SUPPLEMENTARY ASSESSMENT REPORT TO SYDNEY EAST JOINT REGIONAL PLANNING PANEL

Independent Assessment of BD193/2015 for:

39-47 BELMORE STREET | BURWOOD

DATE: 3 OCTOBER 2016

Figure 1: Extract from Concept Landscape Plan – south west corner of the site

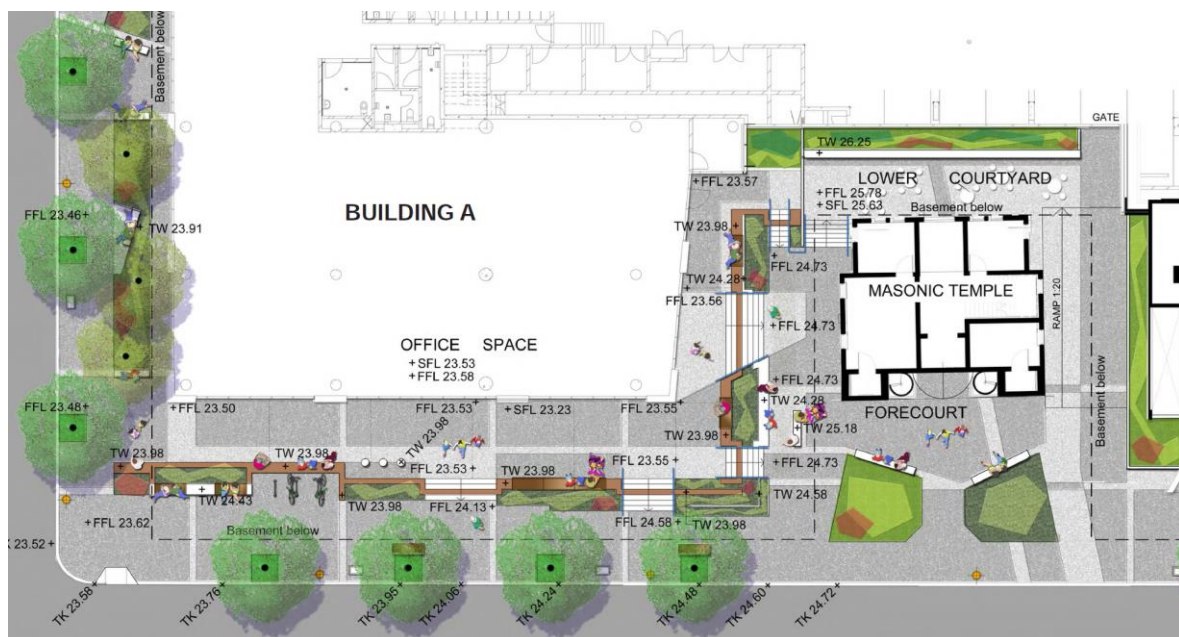
“(9) The landscaped area within the setback between the office premises of Building A and Belmore Street is to be accessible and details of the continuous path of travel are to be included on the plans submitted with the Construction Certificate.”

On 13 October 2016 the applicant provided an email to Council which included a Landscape Concept Plan showing proposed finished levels throughout the setback area to Belmore Street and finished floor levels of the lowest level of Building A. An extract of this Landscape Concept Plan is included in Figure 1 and shows the change in levels across the area adjacent to the southern façade of Building A to be accessible. These details have been included in revised Landscape Concept Plans dated 25 October, 2016. These revised Landscape Concept Plans are included in the list of plans in the recommended conditions of consent in Attachment 1.

This design change has been satisfactorily addressed.
